1723 MEADOWBROOK TERRACE – Replacement Windows, Re-Introducing Windows, Addition of Double Doors on Rear

(25-13-COA)

CITY OF HENDERSONVILLE - COMMUNITY DEVELOPMENT - HISTORIC PRESERVATION
COA STAFF REPORT

REQUEST I: Replacement Rear Kitchen Windows - Site Images

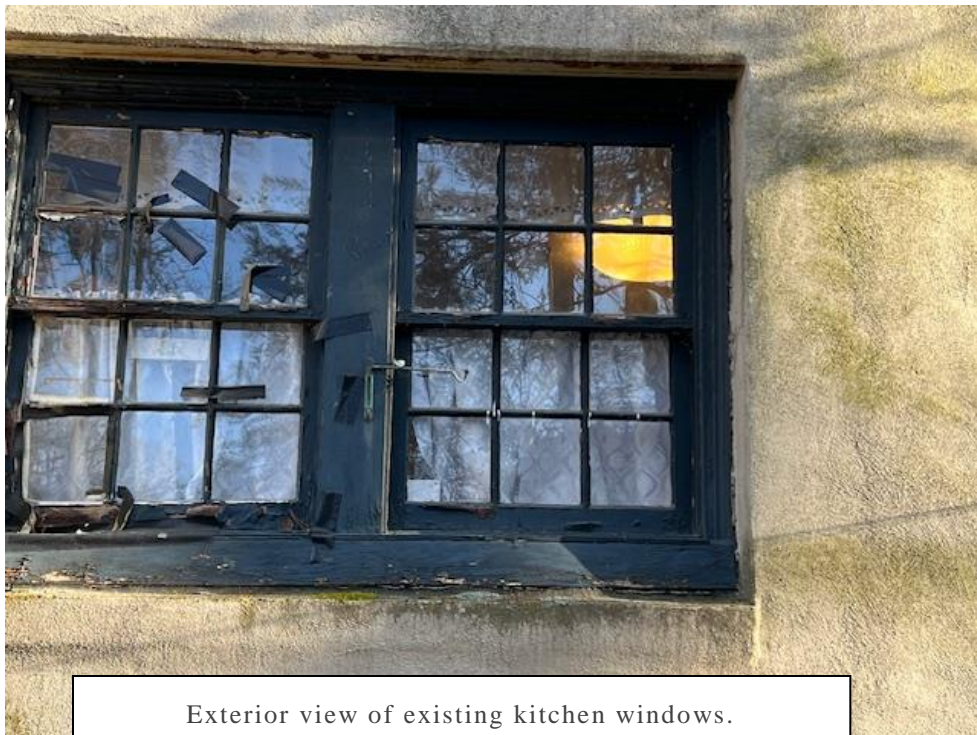
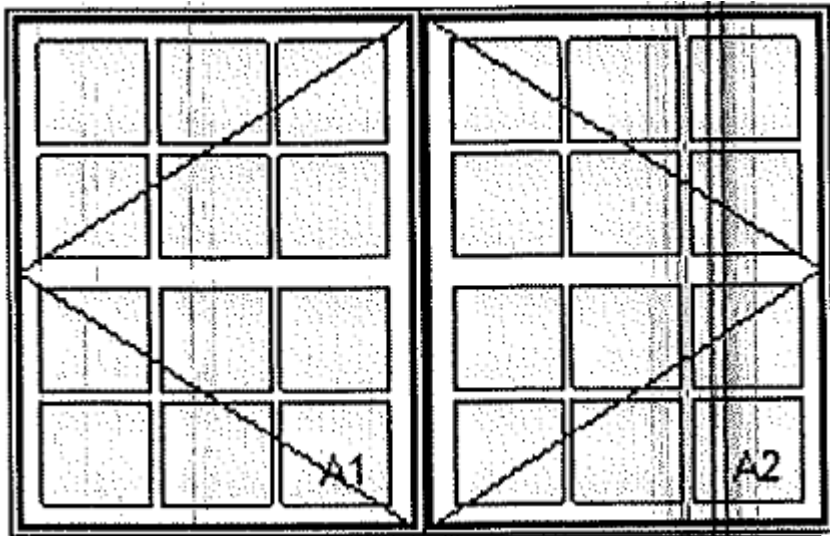
REQUEST I: Replacement Rear Kitchen Windows. The applicant is seeking approval to replace three rear windows. The applicant has proposed replacement windows that mimic the original windows in-kind.

REQUEST I: Replacement Rear Kitchen Windows

Sec. 3.7.4 – Repair historic windows and doors and their distinctive features through recognized preservation methods for patching, consolidating, splicing, and reinforcing.

Sec. 3.7.5 – If replacement of a deteriorated window or door feature or detail is necessary, replace only the deteriorated feature in kind rather than the entire unit. Match the original in design, dimension, and material. Consider compatible substitute materials only if using the original material is not technically feasible.

Sec. 3.7.6 - If replacement of a deteriorated window or door unit is necessary, replace the unit in kind, matching the design and the dimension of the original sash or panels, pane configuration, architectural trim, detailing, and materials. Consider compatible substitute materials only if using the original material is not technically feasible.

REQUEST II: Replacement Casement Windows – Site Photos

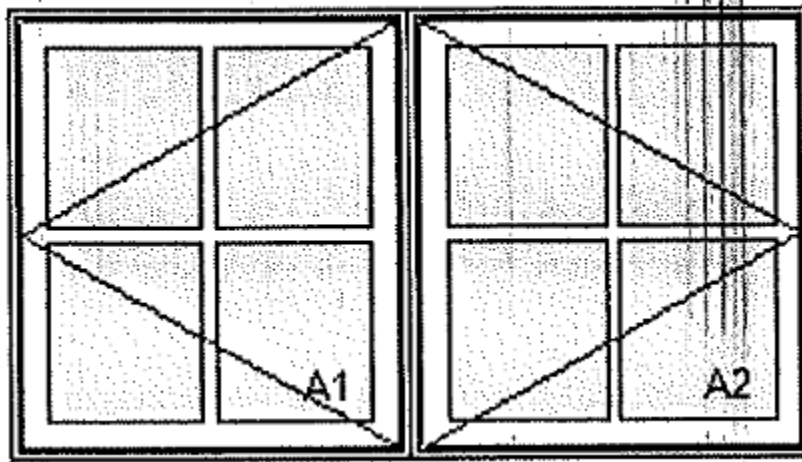
REQUEST II: Replacement Casement Windows. In doing restoration work to the interior of the home, the applicant uncovered casement windows that previously were boarded up. The applicant is seeking approval to expose the casement windows and replace the existing windows with replicas.

REQUEST II: Replacement Casement Windows - DESIGN STANDARDS CRITERIA

Sec. 3.6.7 – If an exterior wall or feature is completely missing, replace it with a new wall or feature based on accurate documentation of the original or a new design compatible with the historic character of the building and district.

Sec. 3.7.4 – Repair historic windows and doors and their distinctive features through recognized preservation methods for patching, consolidating, splicing, and reinforcing.

Sec. 3.7.5 – If replacement of a deteriorated window or door feature or detail is necessary, replace only the deteriorated feature in kind rather than the entire unit. Match the original in design, dimension, and material. Consider compatible substitute materials only if using the original material is not technically feasible.

Sec. 3.7.6 - If replacement of a deteriorated window or door unit is necessary, replace the unit in kind, matching the design and the dimension of the original sash or panels, pane configuration, architectural trim, detailing, and materials. Consider compatible substitute materials only if using the original material is not technically feasible.

REQUEST III: Introducing Double Doors to Rear of Home - Site Photos

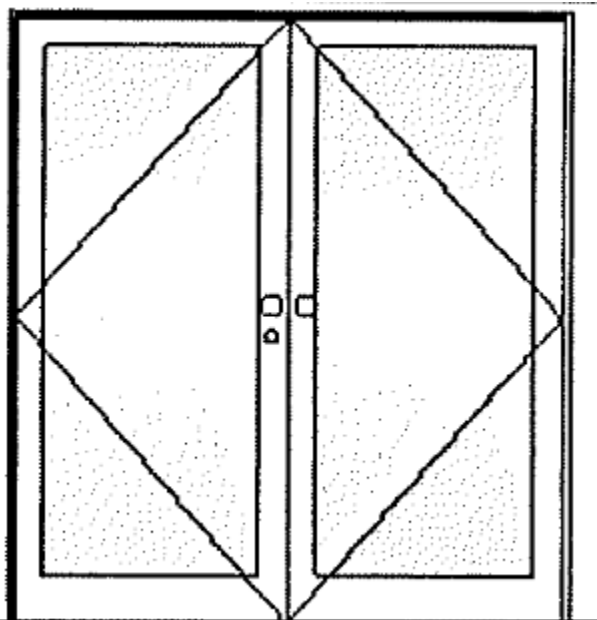
REQUEST III: Introducing Double Doors to Rear of Home. The applicant is seeking approval to introduce double doors to the rear of the home. The applicant would be removing two windows on a side sunporch to create the opening for the double doors.

REQUEST III: Introducing Double Doors to Rear of Home - DESIGN STANDARDS CRITERIA

Sec. 3.6.8 – The original architectural character of exterior walls should be maintained when adding window or door openings, bays, vents, balconies, or chimneys.

Sec. 3.7.1 – Retain and preserve windows that contribute to the overall historic character of a building, including their functional and decorative features such as frames, sash, muntins, sills, heads, moldings, surrounds, hardware, shutters, and blinds.

Sec. 3.7.7 – If a window or door is completely missing, replace it with a new unit based on accurate documentation of the original or a new design compatible with the original opening and the historic character of the building.

Sec. 3.7.9 – If additional windows or doors are necessary for a new use, install them on a rear or non-character-defining elevation of the building, but only if they do not compromise the architectural integrity of the building. Design such units to be compatible with the overall design of the building, but do not duplicate the original.
